Model: VE-P1d	Date: 16-Nov-16	No.: RM136002a
---------------	-----------------	----------------

Subject: Firmware Release Note: Network Support		Prepared by: J. Kitagawa	
From: 2nd Tech Service Sect., MFP/Printer Tech Service Dept.			
Classification:	<input type="checkbox"/> Troubleshooting <input type="checkbox"/> Mechanical <input type="checkbox"/> Paper path <input type="checkbox"/> Product Safety	<input type="checkbox"/> Part information <input type="checkbox"/> Electrical <input type="checkbox"/> Transmit/receive <input checked="" type="checkbox"/> Other (Firmware)	<input type="checkbox"/> Action required <input type="checkbox"/> Service manual revision <input type="checkbox"/> Retrofit information <input checked="" type="checkbox"/> Tier 2

Model: Vesta-P1		Date: 23-Apr-19	No.: RM136019
Subject: Revised laser safety regulation		Prepared by:	
From: Tech Support Sect., Product Marketing Dept.			
Classification:	<input type="checkbox"/> Troubleshooting <input type="checkbox"/> Mechanical <input type="checkbox"/> Paper path <input checked="" type="checkbox"/> Product Safety	<input type="checkbox"/> Part information <input type="checkbox"/> Electrical <input type="checkbox"/> Tra

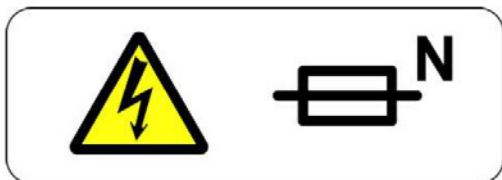
Important Safety Notices → General Safety Instructions

Addition:

For Norway

This product is also designed for an IT power distribution system with phase-to-phase voltage 230V.

19. For machines installed with the anti-tip components:

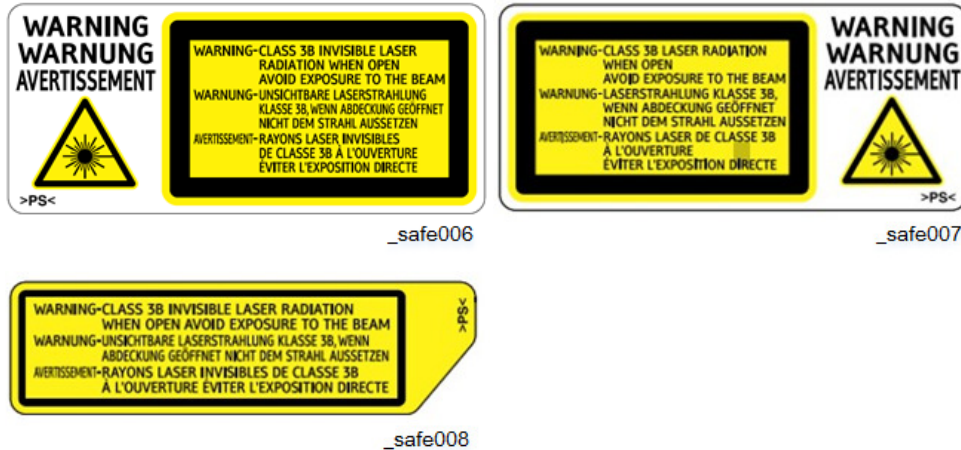
Important Safety Notices → Safety → Prevention of Physical Injury

Correction:

Old Description:

The anti-tip components are necessary for meeting the requirements of IEC60950-1, the international standard for safety. The aim of these components is to prevent the products, which are heavy in weight, from toppling as a result of people running into or leaning onto the products, which can lead to serious accidents such as persons becoming trapped under the product. (U.S.: UL60950-1, Europe: EN60950-1) Therefore, removal of such components must always be with the consent of the customer. Do not remove them at your own judgment.

New Description:

The anti-tip components are necessary to prevent the products, which are heavy in weight, from toppling a result of people running into or leaning onto the products, which can lead to serious accidents such persons becoming trapped under the products. Therefore, removal of such components must always be with the consent of the customer. Do not remove them at your own judgment.
